## Site Plan Review

Site: 26600 Southfield Road  
Applicant: BD & E Group, LLC  
Plan Date: December 30, 2024  
Zoning: MX Mixed Use District  
Parcel ID: 24-24-104-033  
Proposal: Interior / Exterior Commercial Building Renovation

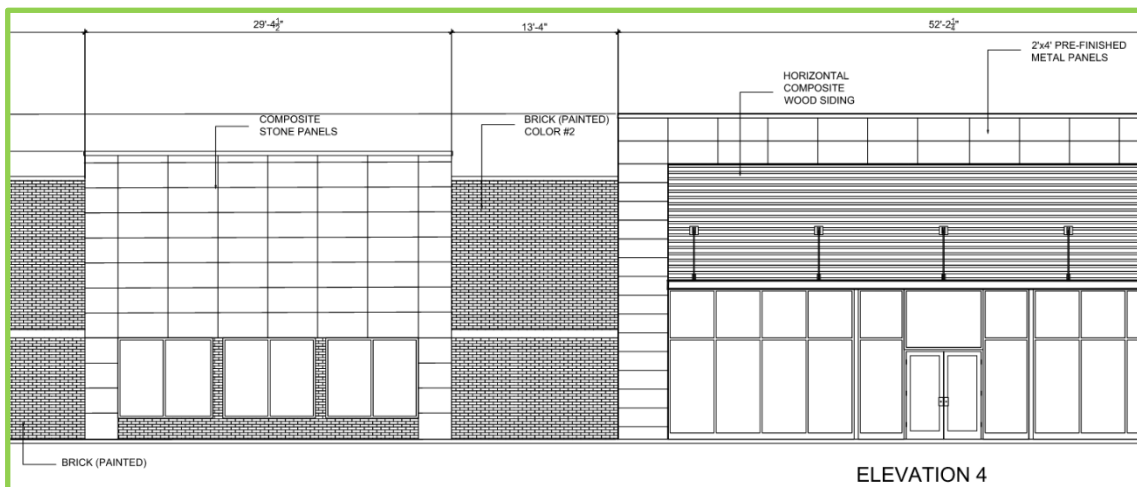
The previous version of the plan included metal panels consisting of about 36% of the overall front façade of the building. The ordinance allows up to 10% of trim material to be wood, aluminum, or other material of equal strength and durability. Given the excessive amount of metal paneling, the Planning Commission, at the December 17, 2024 meeting, requested the applicant to increase the amount of brick, stone, or other masonry materials required by the ordinance.

Review of the updated plan estimates the metal panels have been reduced to approximately 7.42% of the overall front façade. Additionally, about 400 square feet of composite wood siding is shown above the midsection of the building, as partially seen in the graphic below. Wood is also a trim material that is limited to 10% of the façade. When combined with the metal panels, about 15.3% of the front of the building is metal or wood siding. The remaining materials shown to be used on the building include:

- Painted brick:.....about 45.45%
- Composite stone panels:.....about 18.54%
- Glass/transparent panels:.....about 18.12%

The applicant has been notified of the determination that use of the restricted materials continues to exceed the maximum allowed by the ordinance. Additionally, the applicant has been asked to confirm the proposed color palate of the building. We anticipate the applicant to be present at the January 21, 2025 meeting to discuss the updates to the project with the Planning Commission. As previously stated, the applicant may consider providing samples of the proposed materials for the Planning Commission to discuss with the applicant.
